Genesis Solar Energy Project Eastern Riverside County, California

**Amendment
(09-AFC-8)**

DOCKET 09-AFC-8C

April 2012

**FIGURE 4
OPTIONS A & B
VIEW 3**

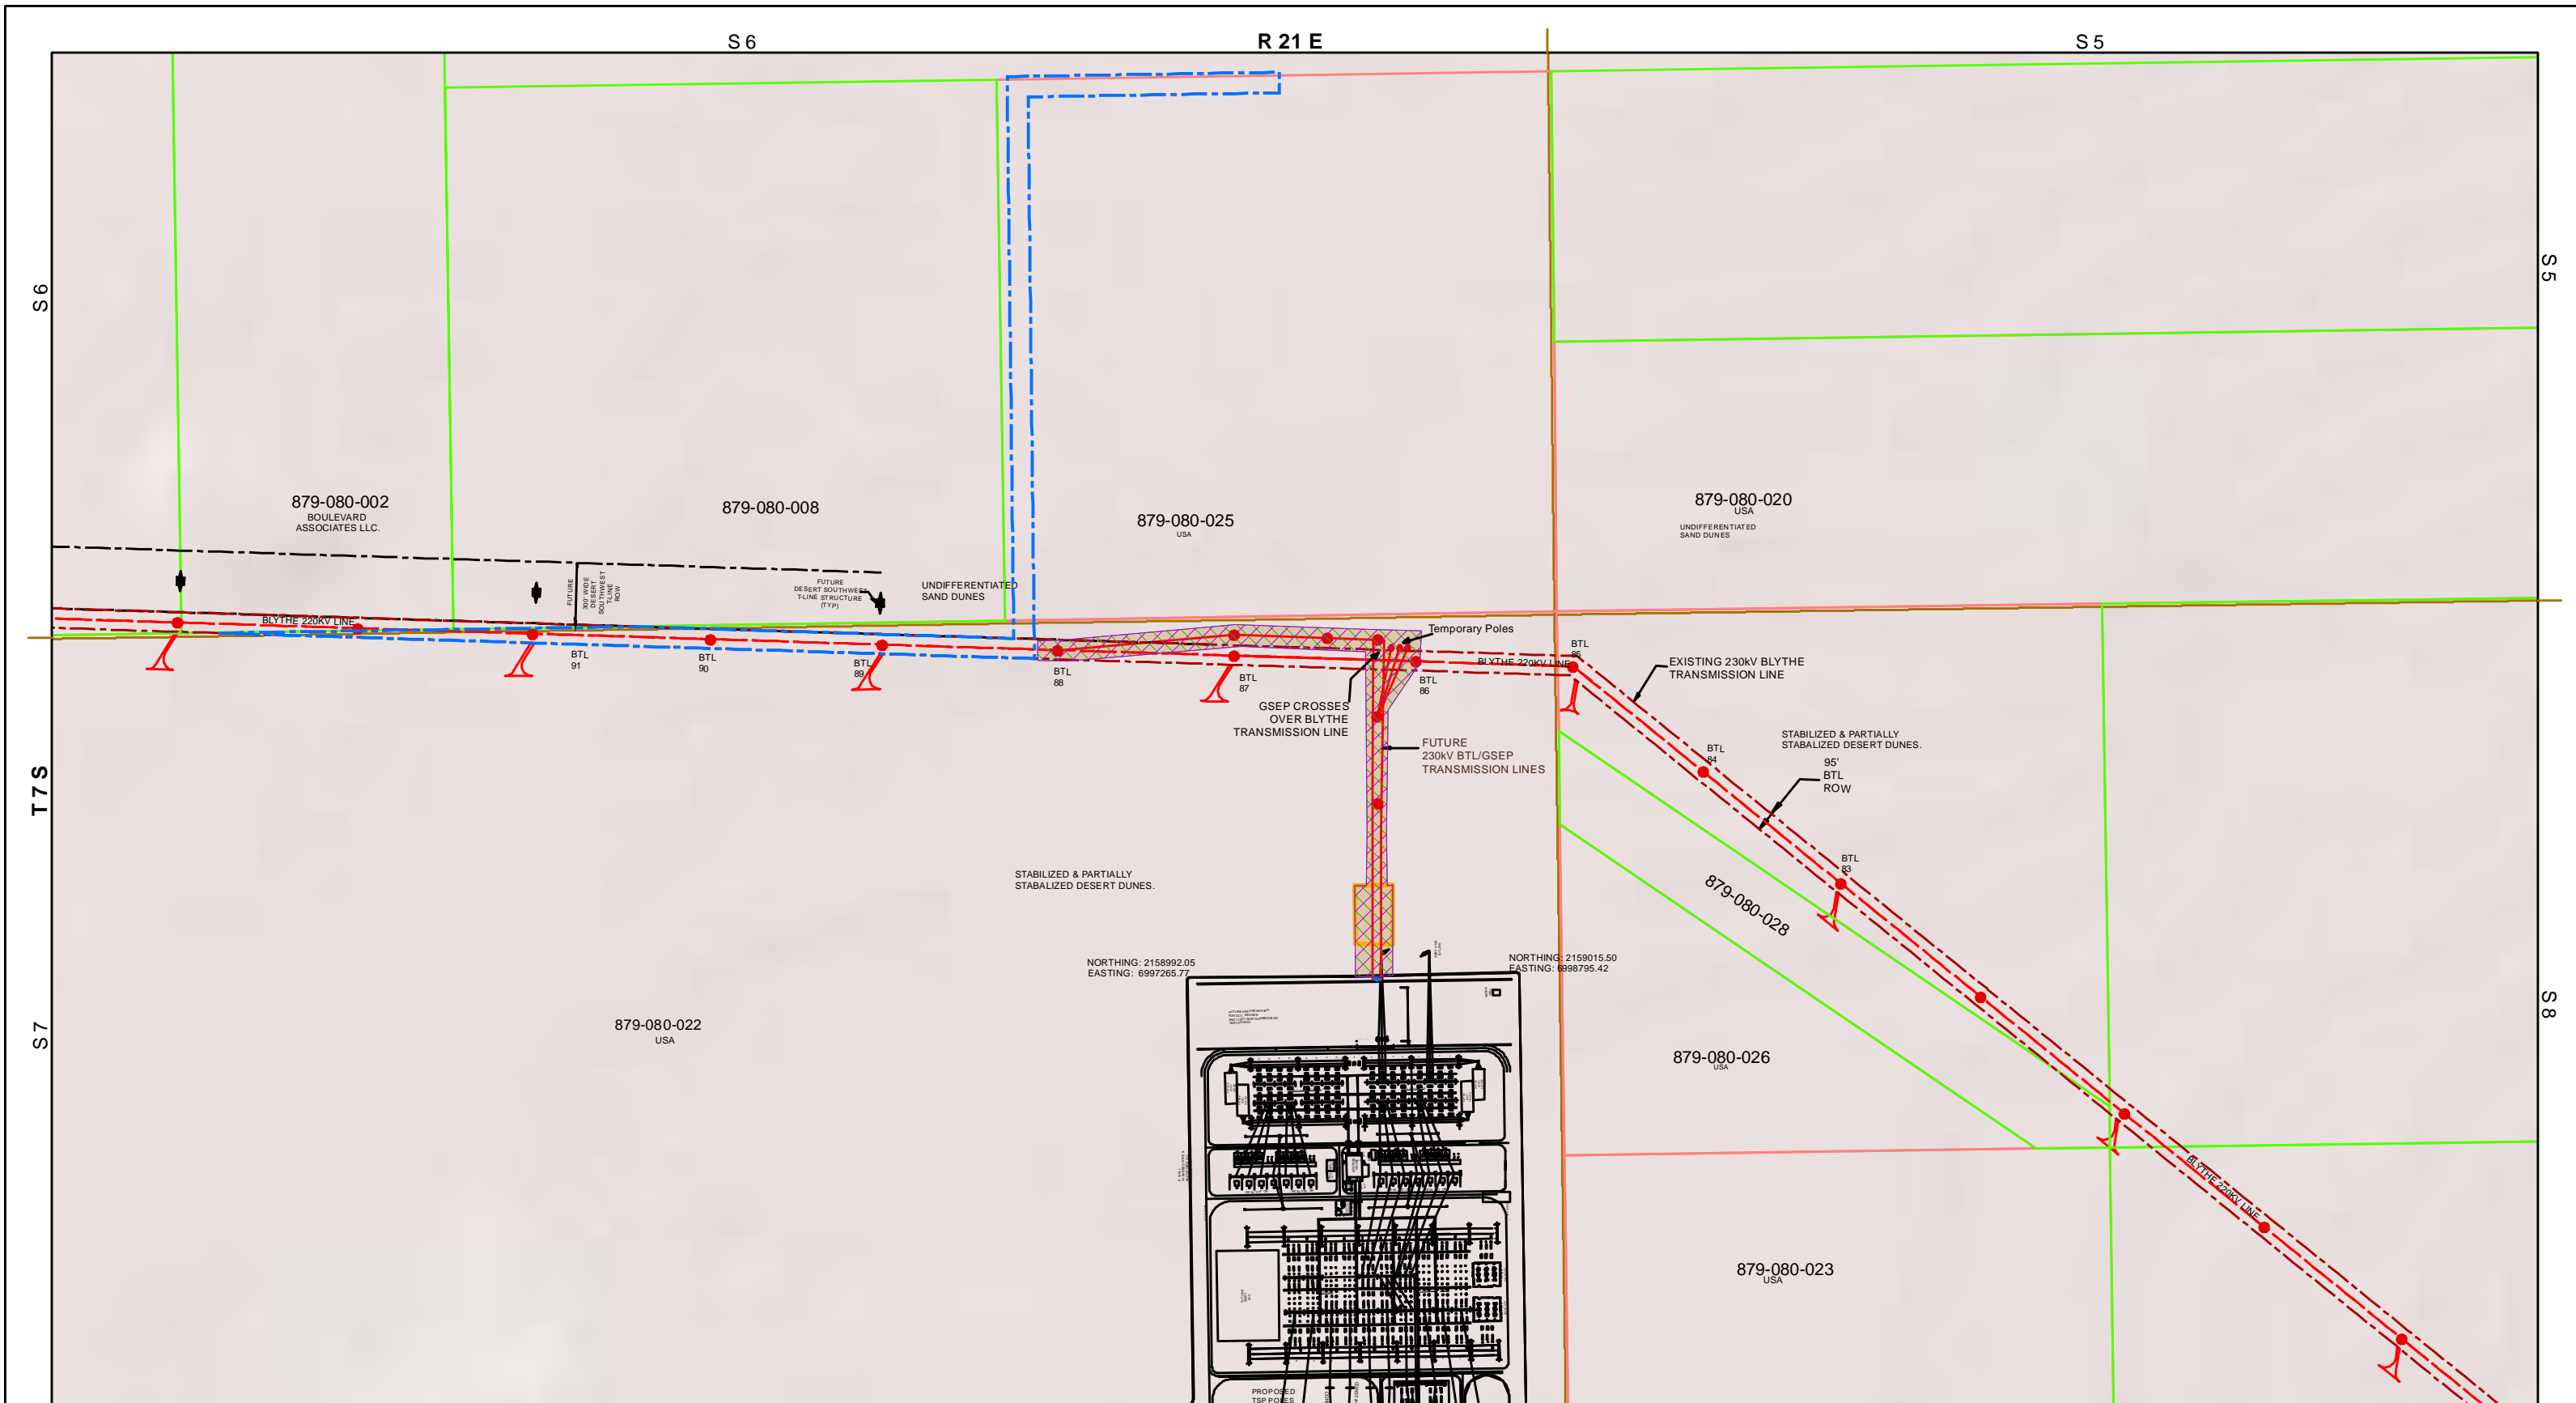
Option A will require some additional ROW to the north of the LS (formerly BETL) transmission line just before and after the 90 degree turn to the south towards the CRS (see Figure 4, View 3). This area has been extensively surveyed for biological purposes. No impacts are expected from this request for additional ROW.

Option B will require some addition ROW to the north of the LS Power (formerly BETL) transmission line just before and after the 90 degree turn to the south towards the CRS (see Figure 4, View 3). This is the same configuration as Option A. Again, this area has been extensively surveyed for biological purposes.

**FIGURE 5
GSEP RING BUS/SWITCHYARD
VIEW 4**

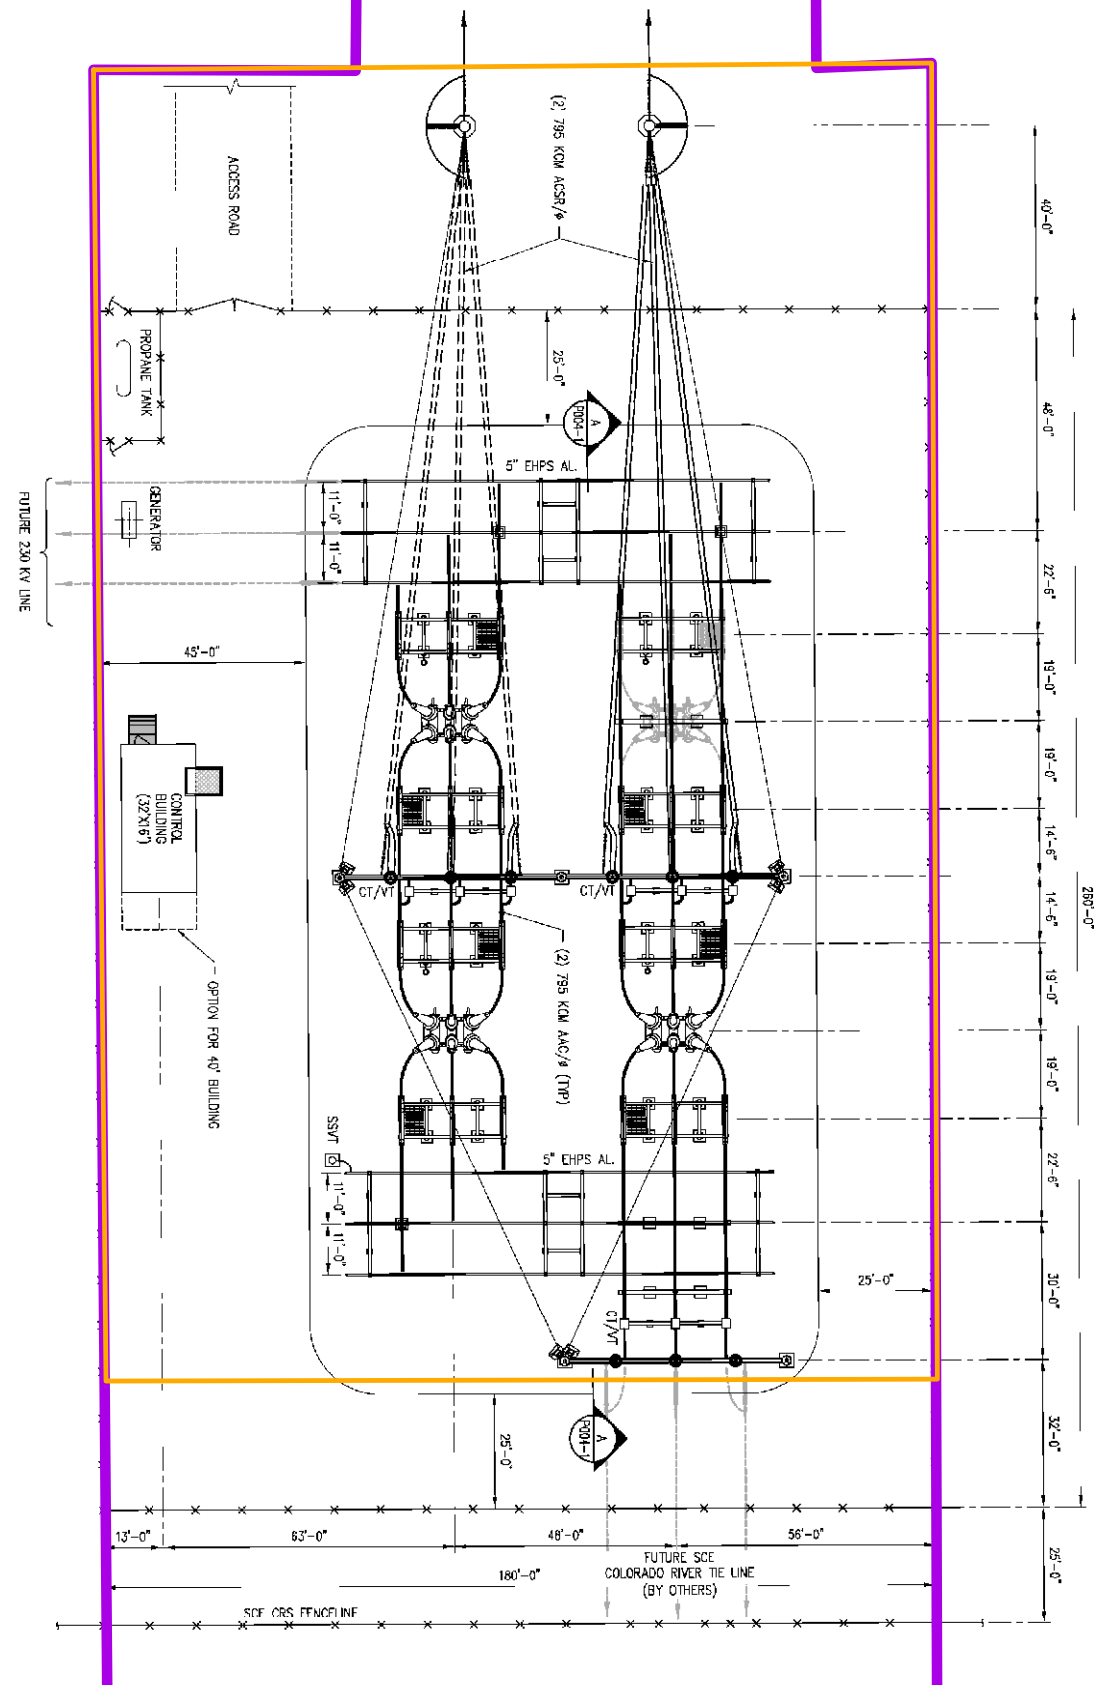
After crossing the BETL, the GSEP double-circuited 230 kilovolt (kV) line will run approximately 1600 ft. to the GSEP ring bus (see Figure 5, View 4 and Figure 6, One Line Diagram). This stretch includes two new double-circuited 230 kV poles and a ring bus/switchyard structure north of the CRS. Inside the ring bus, will be a new, three-breaker 230 kV switchyard (i.e. no voltage transformation) located 100 ft. north of the northern the CRS perimeter wall (pursuant to SCE offset requirements) and aligned (east-to-west) so as to facilitate a connection to CRS 230 kV Bay 7 while minimizing any impediments to future transmission line connections to other CRS 230 kV Bays.

Figure 6
One Line Diagram/Ring Bus

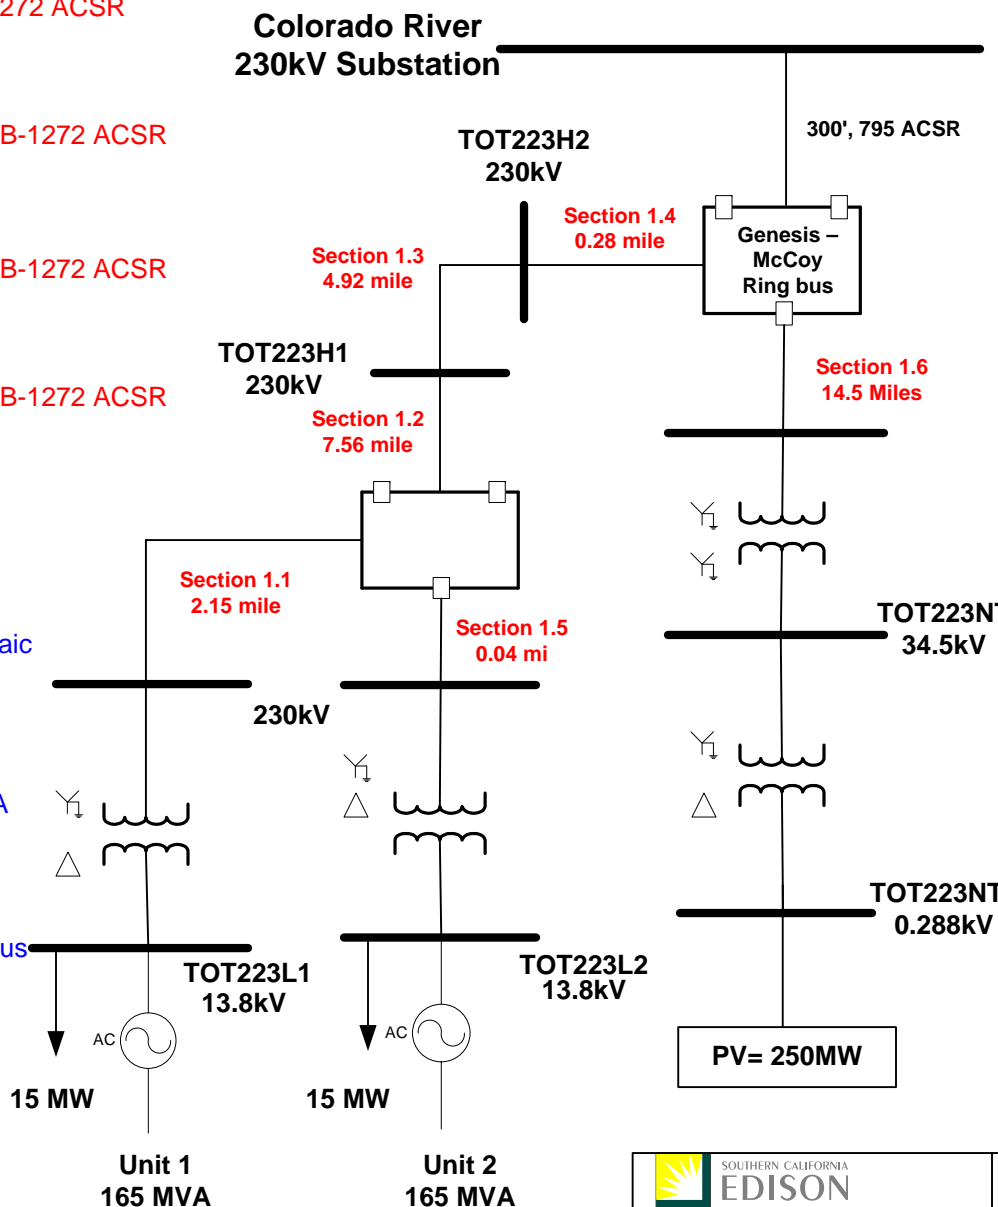
The ring bus/switchyard will also serve to accommodate the various breakers, switches, line protection scheme, RTUs and telecommunication paths for the Special Protection Scheme required under the LGIA. The ring bus will support the full interconnection requirements necessitated by the LGIA and will allow GSEP to operate continually, without interruption, as other phases of the interconnection facilities and network upgrades are completed.
